NEW ELEMENTARY SCHOOL
9801 HIGHLAND KNOLLS DR
BAKERSFIELD
CALIFORNIA
93306

NEW MIDDLE SCHOOL
4115 VINELAND ROAD
BAKERSFIELD
CALIFORNIA
93306

DETAILS

SHEET IDENTIFICATION NUMBER
E-002
SHEET OF

TRENCHING DETAIL

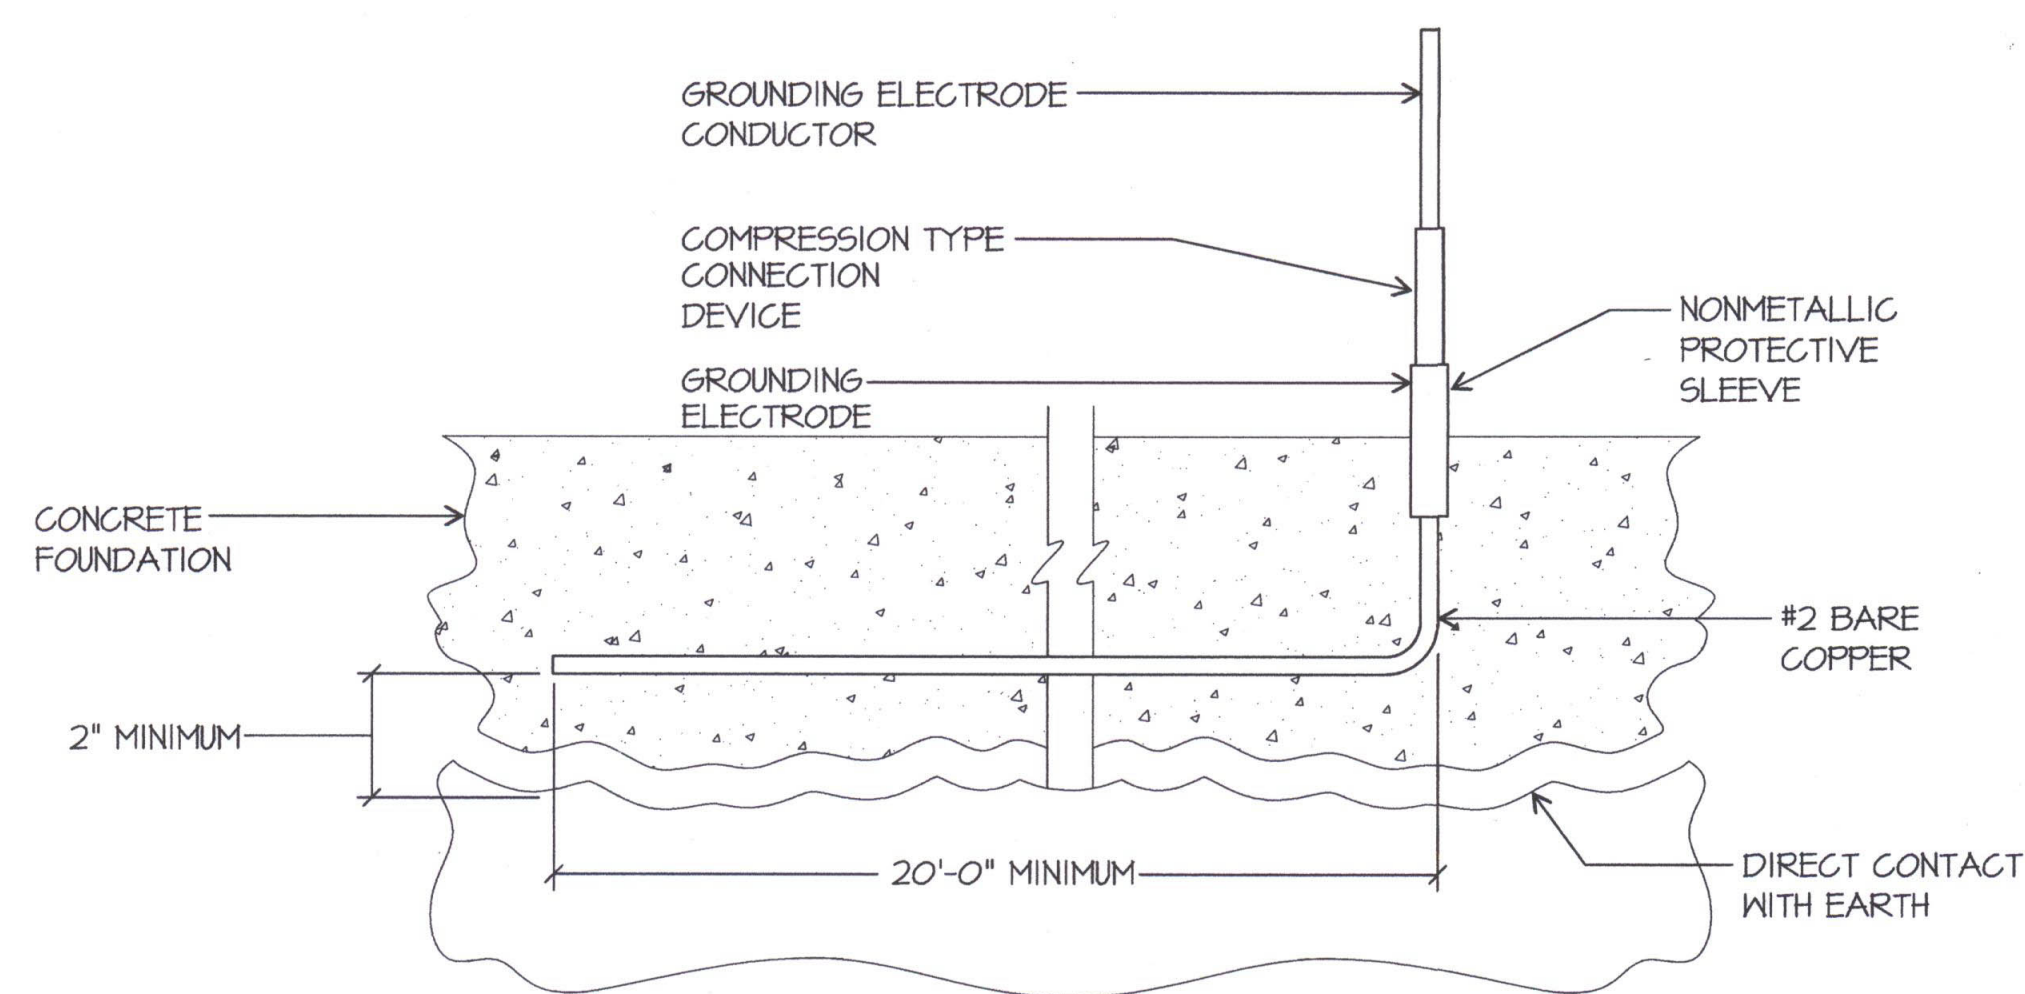
REQUEST:
RDM Electric - 6/8/12
Reference Sheet E-002
On Detail B of the Electrical Drawings, it calls for red colored concrete for the underground
duct bank encasement. Is it acceptable to use red brick dust to color the concrete encasement
in lieu of installing red colored concrete. Please advise.

ANSWER:
1. yes
2. Provide a cost proposal for the credit to delete encasement on all u/g conduits except
RDM conduits.
John Maloney / JMPE 6/7/12

ROOF RECEPTACLE MOUNTING DETAIL

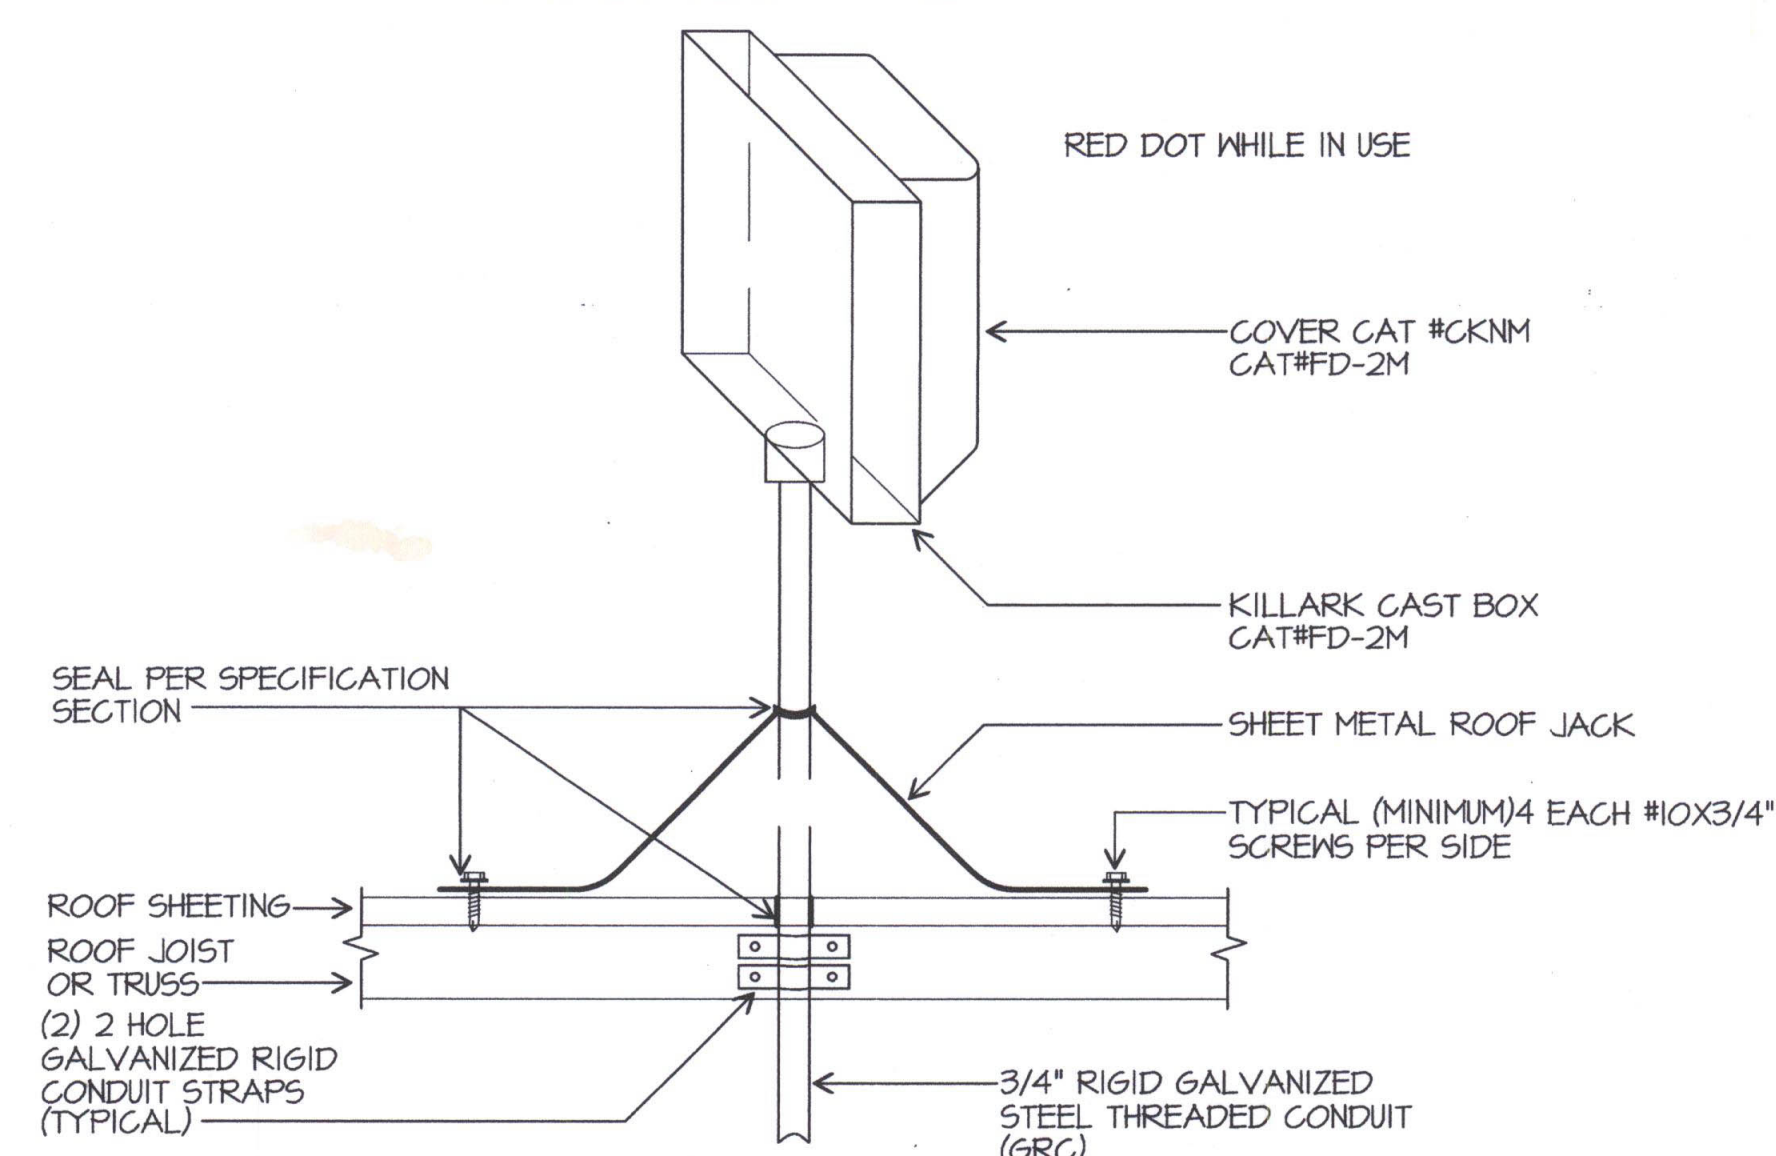
REQUEST:
RDM Electric - 3/19/13
Reference Sheets E-002, E132A, E132B, E132C, E132D, E132E, E132F, E132G, E132H, E132I, E132J, E132K, E132L, E132M & E132P
The Electrical Plans show weatherproof (GP) receptacles to be installed on the exterior of all of
the buildings, however, it does not show what type of weatherproof cover that is to be used. Is
it acceptable to use the same cover for these receptacles as what is shown on Detail E, sheet
E-002 for the roof receptacles? Please advise.

ANSWER:
John Maloney - JMPE - 3/19/13
It is acceptable to use the same cover for these receptacles as what is shown on Detail E,
sheet E-002 for the roof receptacles.
